100/300 AREA UNIT MANAGER MEETING ATTENDANCE AND DISTRIBUTION

100/300 AREA UNIT MANAGERS MEETING
APPROVAL OF MEETING MINUTES

November 4, 2010

100 & 300 AREA UNIT MANAGER MEETING MINUTES**Groundwater and Source Operable Units; Facility Deactivation, Decontamination, Decommission, and Demolition (D4); Interim Safe Storage (ISS); and Mission Completion****November 4, 2010****ADMINISTRATIVE**

DCN- 0100H-DD-C0243-01-01

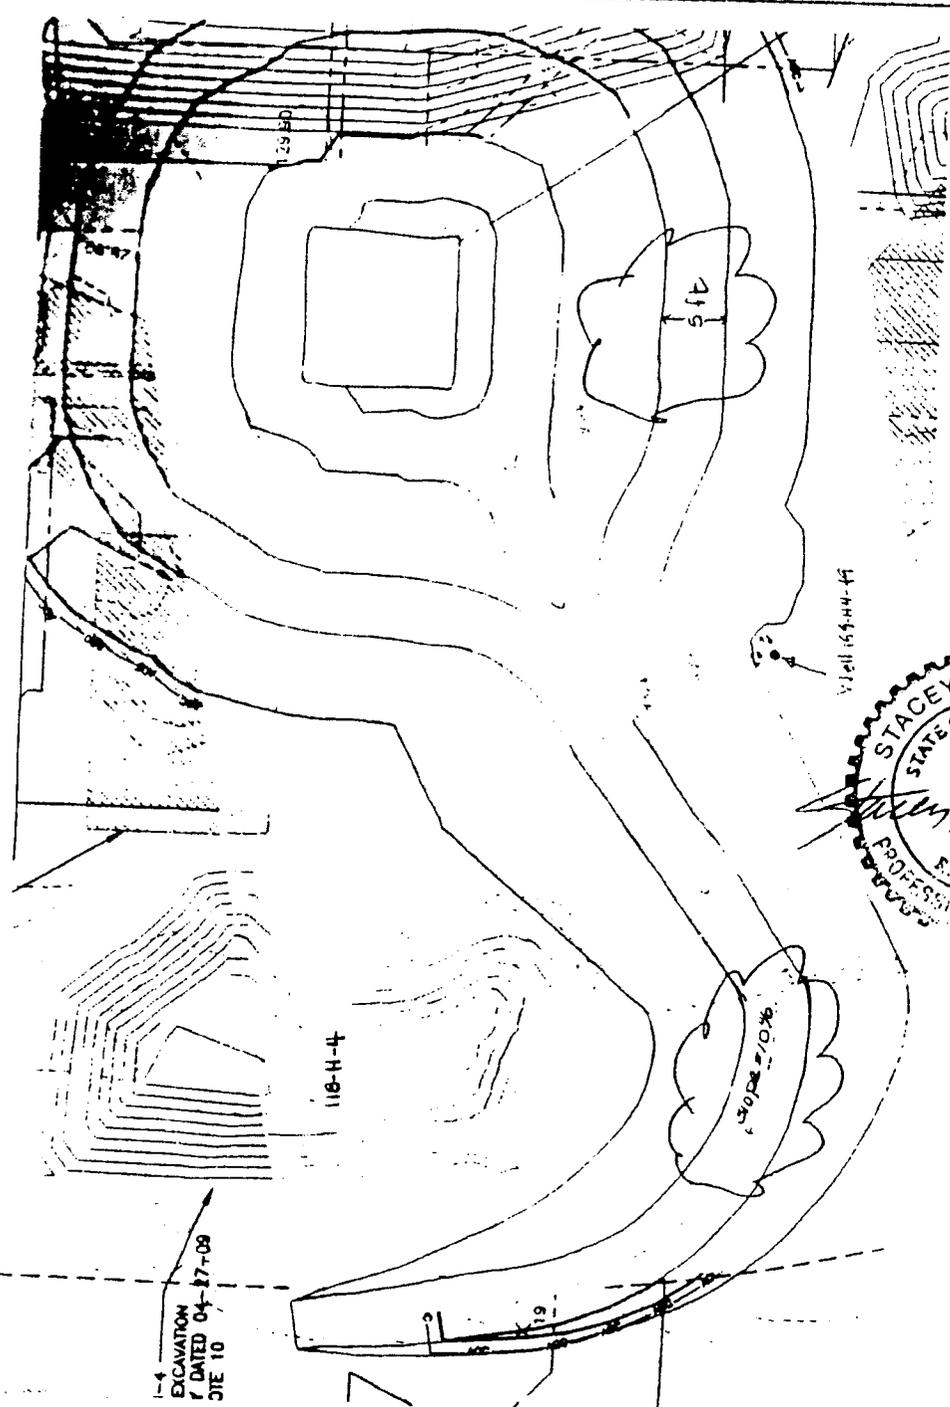
Hi Mandy, we need to modify the drawing for the 132-H-3 to increase the grade for the entry ramp from 6% to 10% to allow rock trucks to get deeper into the excavation to load out material, see attached drawing. It looks like a small portion of the layback to the south of 118-H-4 may be impacted. We will make every attempt to avoid taking any material associated with the upper portion of the south layback of 118-H-4 if I can convince operations that a 1.5 to 1 slope isn't necessary since personnel shouldn't be accessing any portion of the site near that area. I believe the CVP for 118-H-4 has already been reviewed by Ecology and you and Megan's group are finalizing

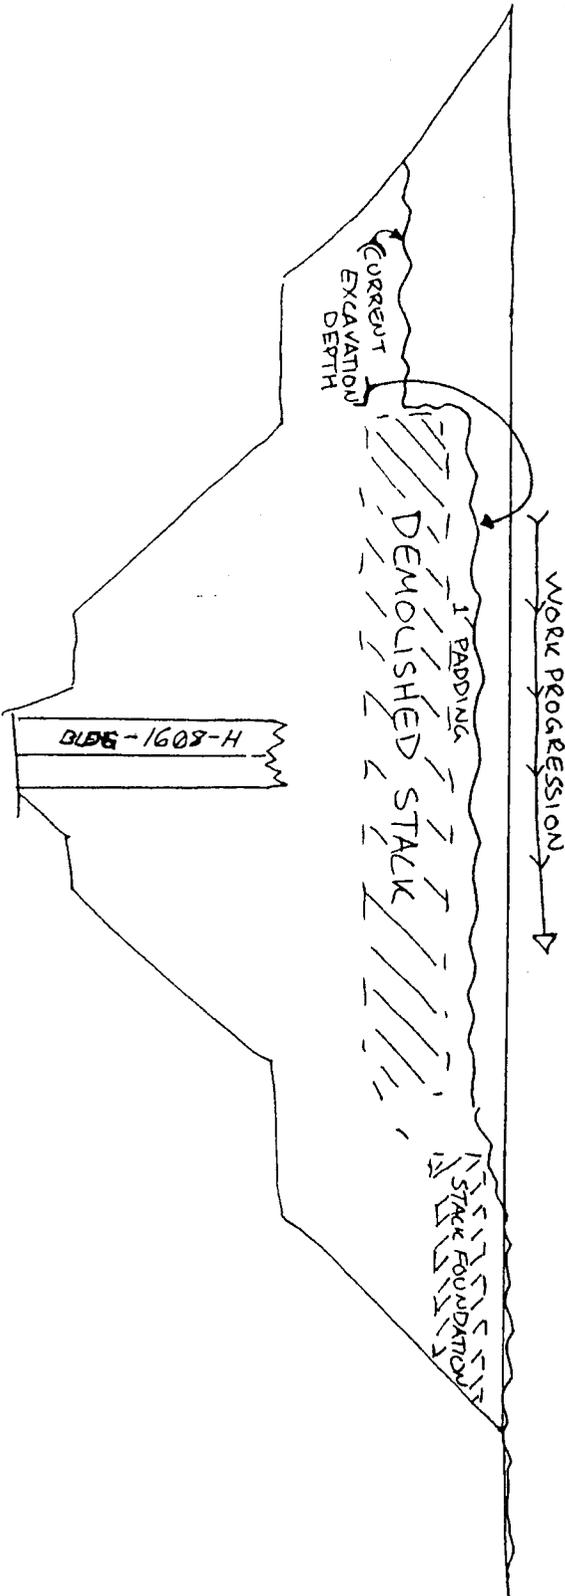
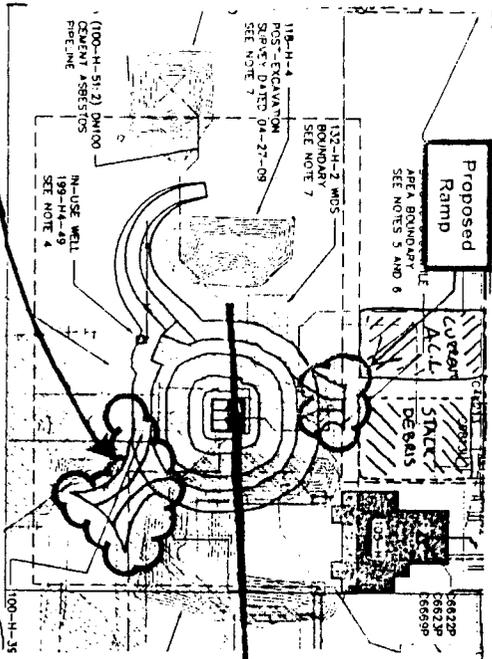
In addition to the stockpile areas, the subcontractor also needs to build two more ramps. One on the southeast side to facilitate the remediation of the 132-H-3 site. The other is on the north to facilitate the remediation of the 132-H-1, 116-H Reactor Exhaust Stack Burial Site.

If acceptable, WCH would appreciate your concurrence to develop the additional stockpile areas and ramps. Your prompt attention by October 13 to these matters will be appreciated.

If DOE is in agreement; based on the information provided, Ecology is approving the request for additional staging pile areas for the 132-H-3 waste site, as identified on the drawing provided October 7th, 2010.

Please ensure that these staging piles are operated in accordance with the Section 4.5.2 in the RDR/RAWP for the 100 Area, DOE/RL-96-17, Rev 6. Additionally, please ensure that all contaminants of concern (COCs) for 132-H-3 are carried forward into the verification sampling plan for these staging pile locations.

It is unclear from your e-mail if you intend to use these staging pile areas for soil from 132-H-1 waste site also. If these staging pile areas are also used to stage soil for 132-H-1, the COCs for 132-H-1 will also need to be carried forward into the verification sampling plan for these staging pile locations.

Please have this agreement captured in the 100/300 Area UMM minutes along with the updated civil drawing, which clearly identifies the staging pile locations.

WCH JOB NO.	14655	DOE CONTRACT NO.	DE-AC06-05R-14655	CAO FILENAME	100C0493.DWG
TASK	1000	DRAWING NO.	01000-DD-00493	REV. NO.	3

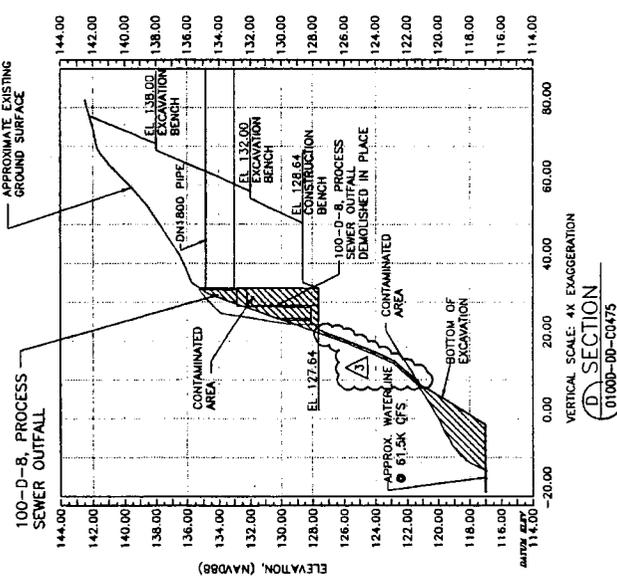
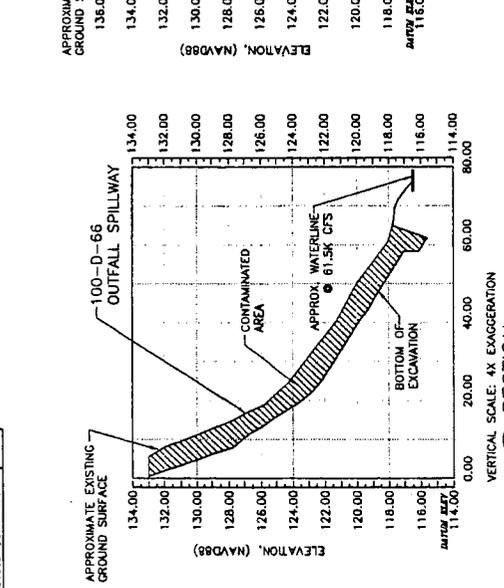
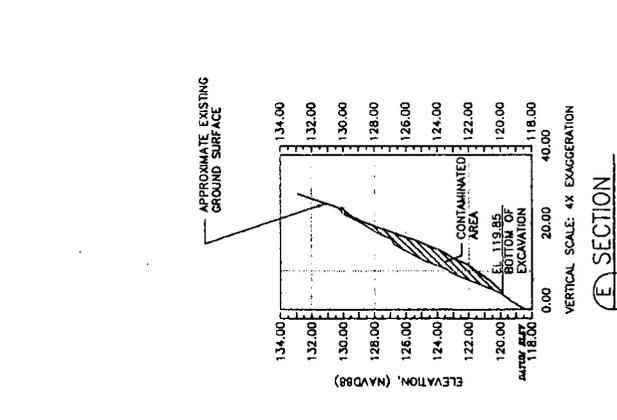
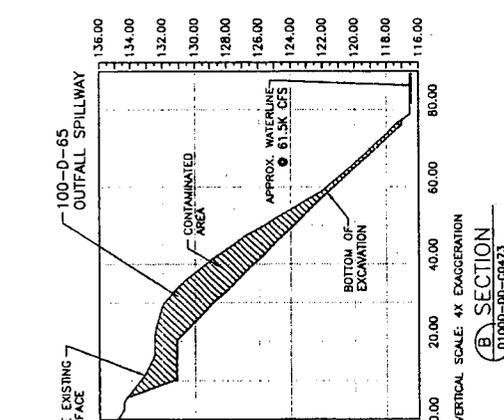
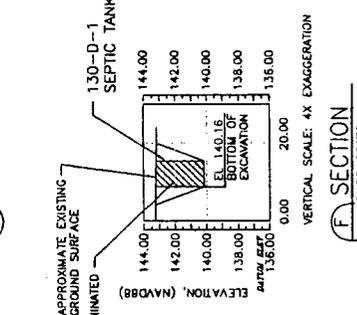
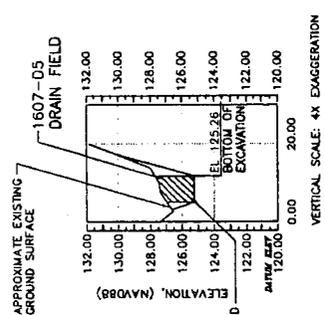
3. Cross section "D" on drawing 0100D-DD-C0493 shows contaminated areas at the top and bottom of the outfall. The area in between is not shown as contaminated. The basis for this is not clear. The area in-between should be noted as contaminated and removed to ERDF.

3. Drawing 0100D-DD-C0493 needs to be updated to include the revised D cross section that was provided in response to Ecology comment by WCH on 8/26/10. Please provide this.

Response – Agreed. The intent is to remove the area in between as contaminated with disposal to ERDF. However, because of the drawing scale used for the cross-section, we agree that the cross-section is not clear in that regard. The cross-section is being revised

as indicated on the attached scan to more clearly indicate that the in between material is to be excavated as contaminated material.

100 D/DR AREA
FY08 REMAINING SITES REMEDIAL ACTION
CIVIL PLOT PLAN - 1: 100-D-66

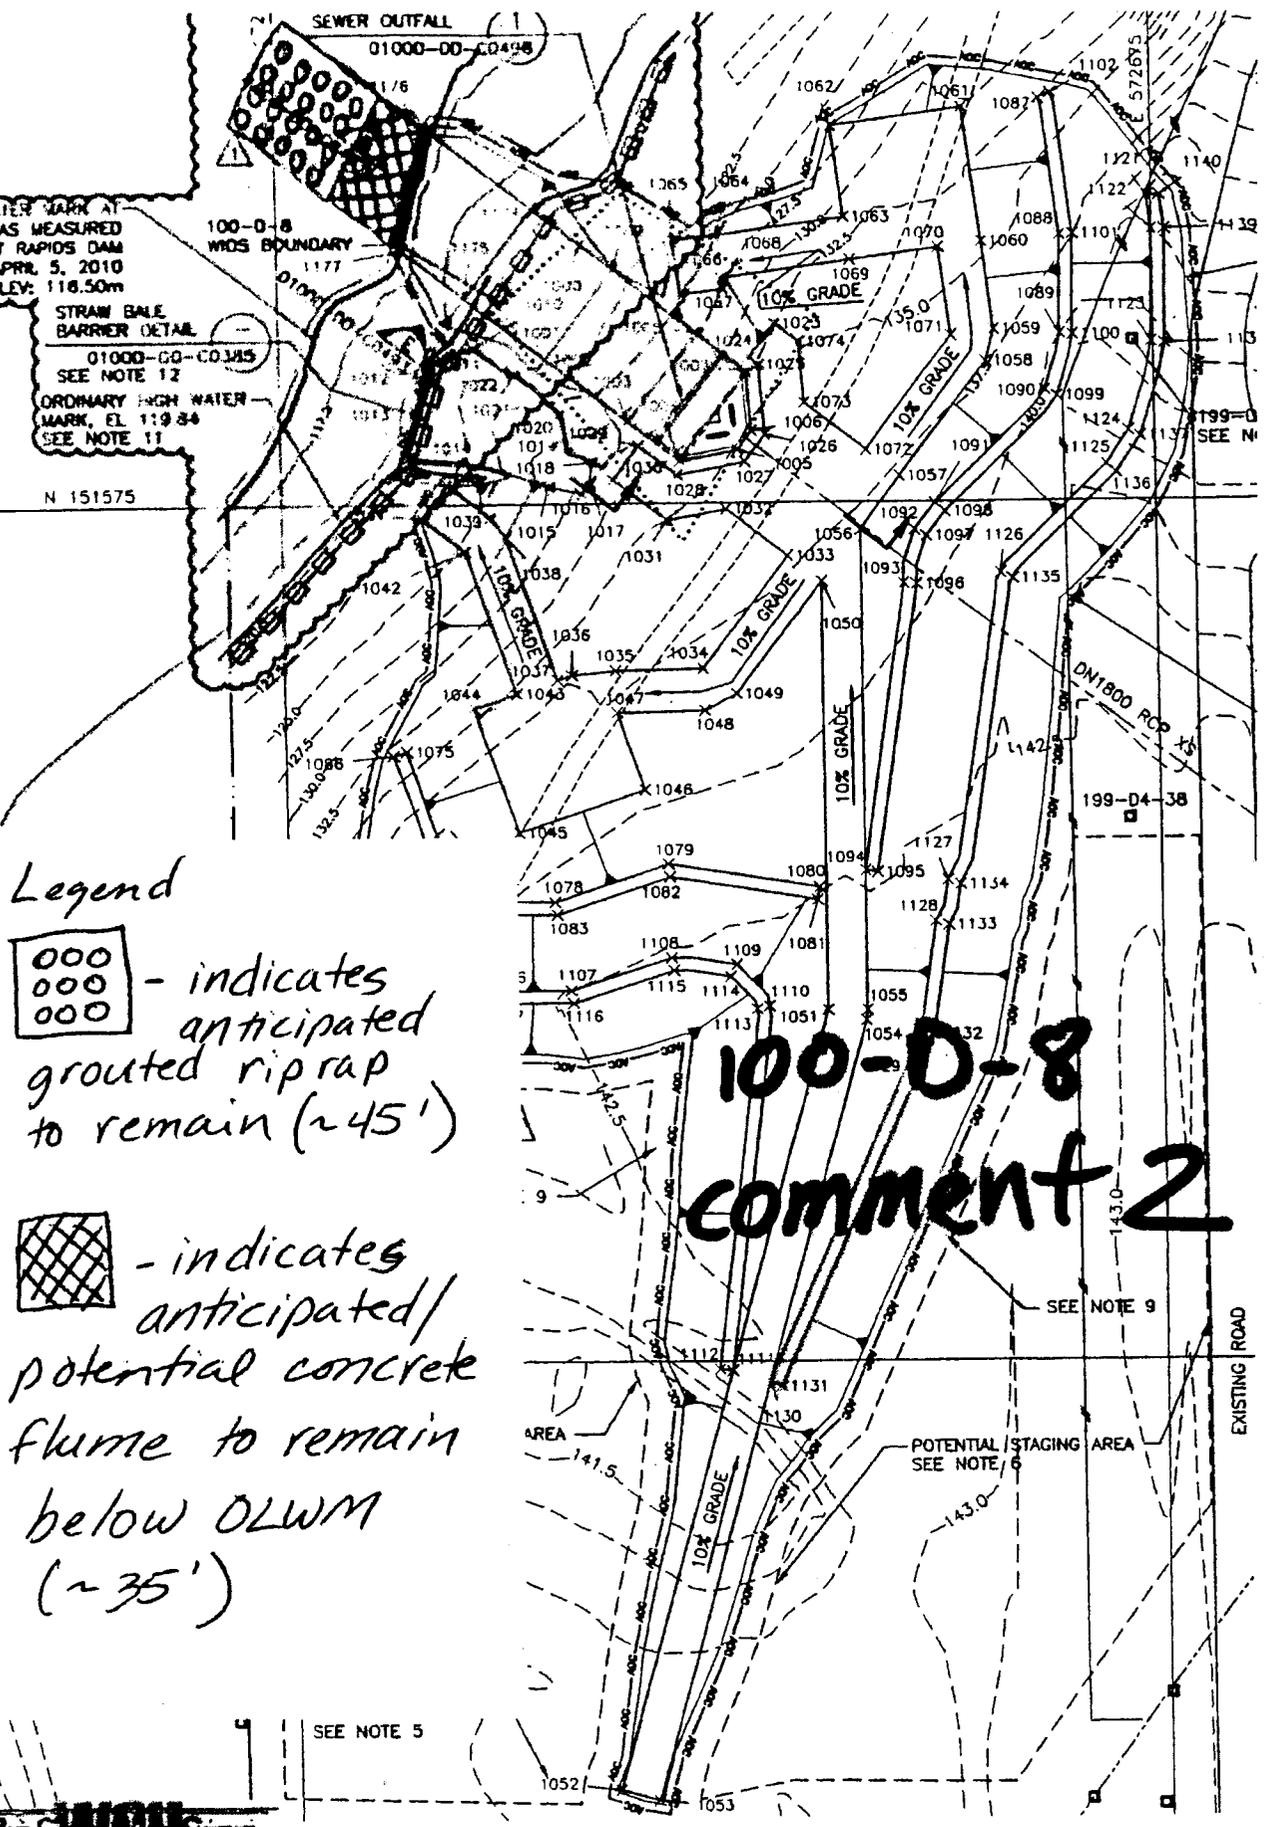
- Add note per comment #1
- Remove project limit and add note per comment #2
- Revise drawing label per comment #3
- Add note per comment #6

2. Drawing 0100D-DD-C0472 needs to clearly document that all of the spillway will be removed, including the area northwest of the "project limits" identified on this drawing. Add a note stating, "The entirety of the spillway, including all concrete structures, rip-rap, and grout will be removed to a maximum extent of the ordinary low water mark." Also, it is not clear what the line identifying the "project limits" identifies, please clarify.

3. Drawing 0100D-DD-C0472 identifies the 116-DR-5 WIDS Boundary. Is this truly the 116-DR-5 outfall boundary or the 100-D-66 spillway boundary? Please clarify and correct.

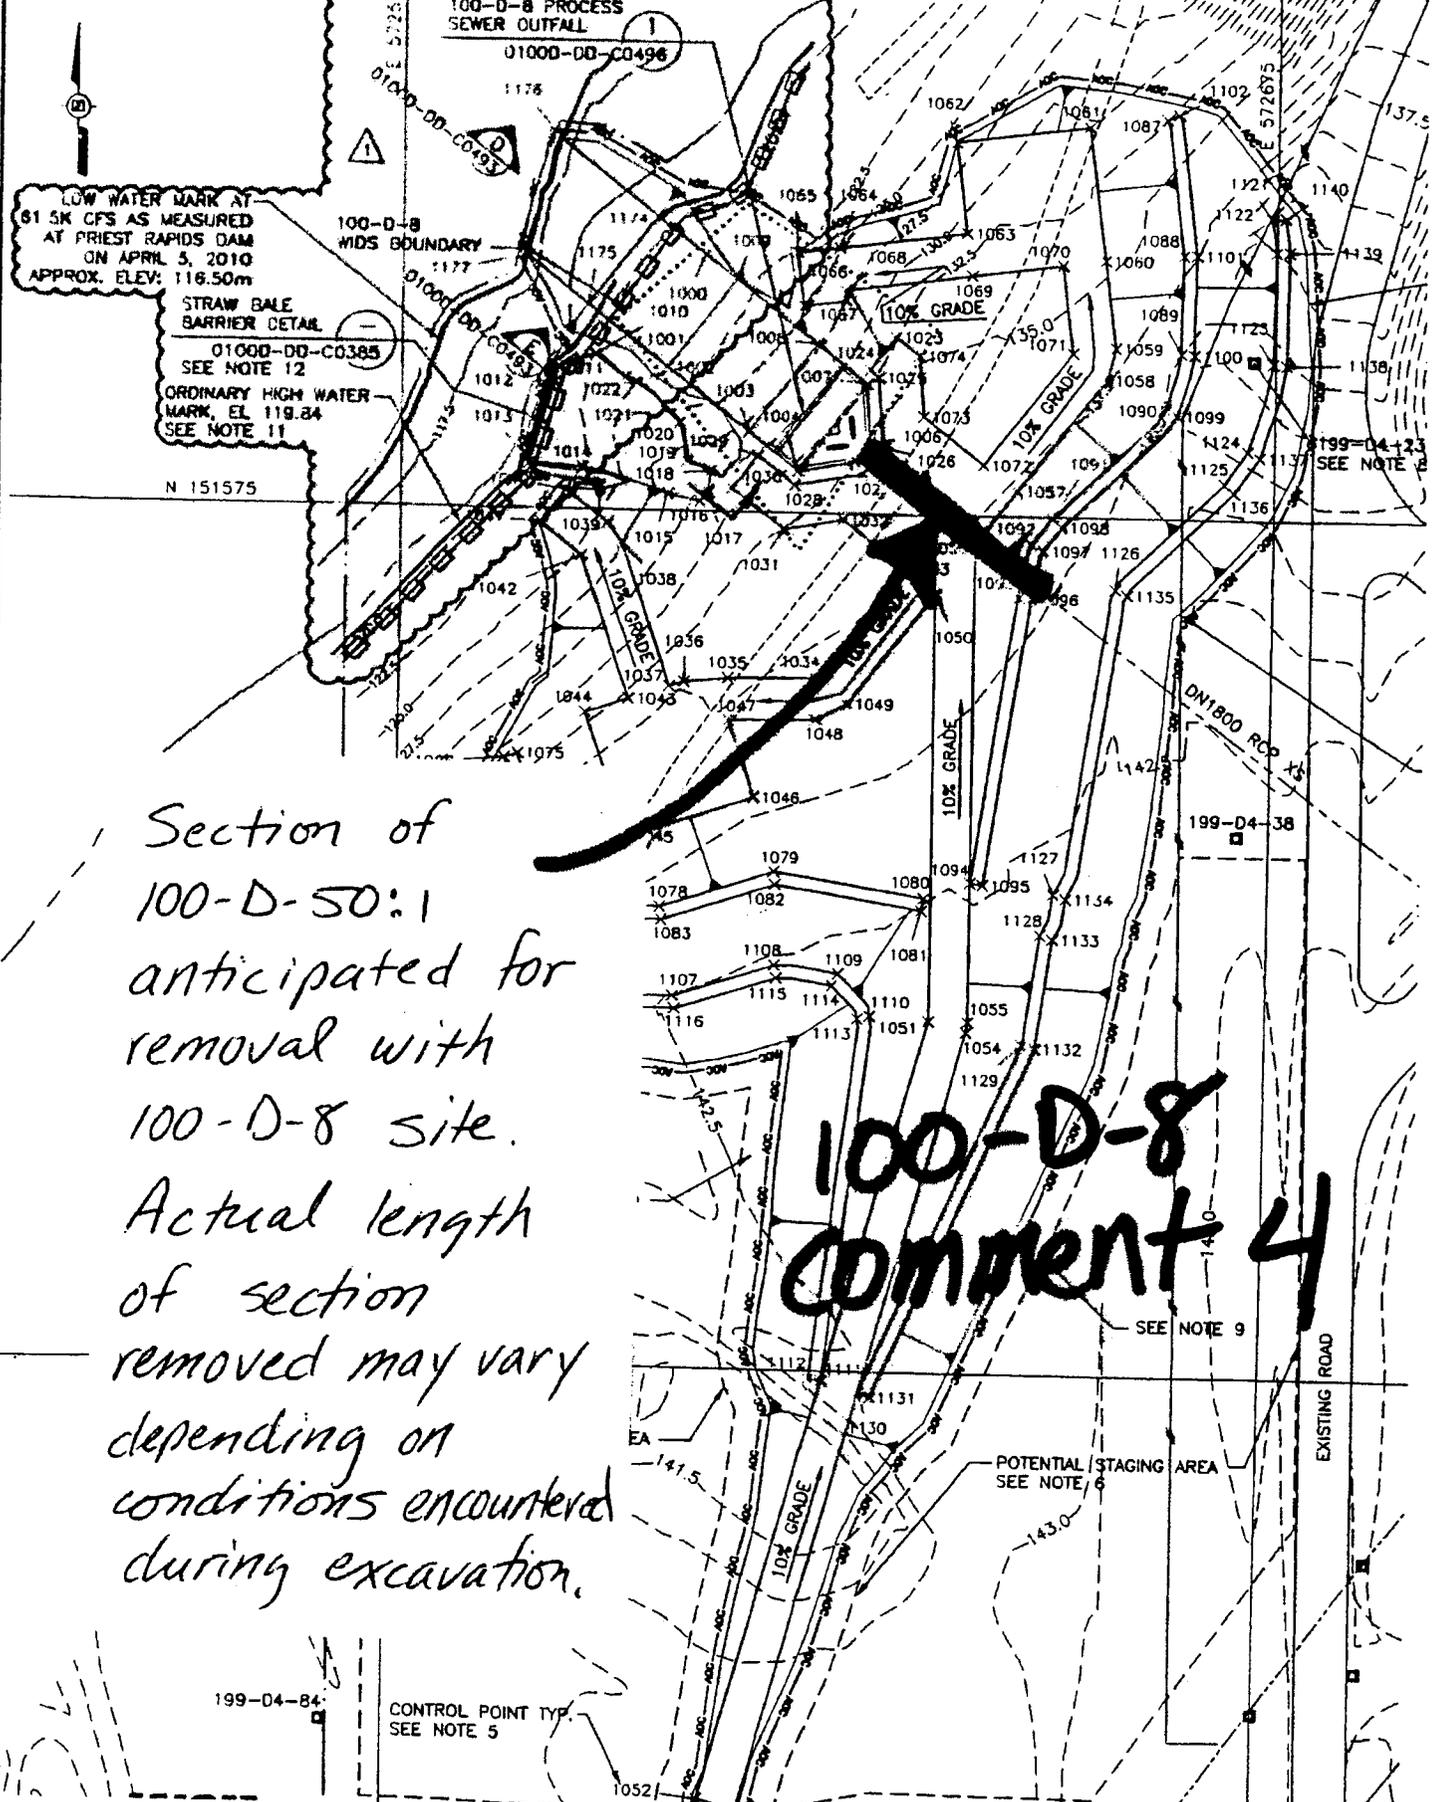
2. The PRSVP for 100-D-8, Figure 2, shows a large magnetic anomaly. Please clarify whether it is anticipated that this anomaly will be encountered during excavation and/or how it will be addressed in the remediation strategy.

Response – Agreed. Depending on conditions encountered during actual remediation of the 100-D-8 site there is the potential that well 199-D4-23 may not require decommissioning for the 100-D-8 remediation activity.
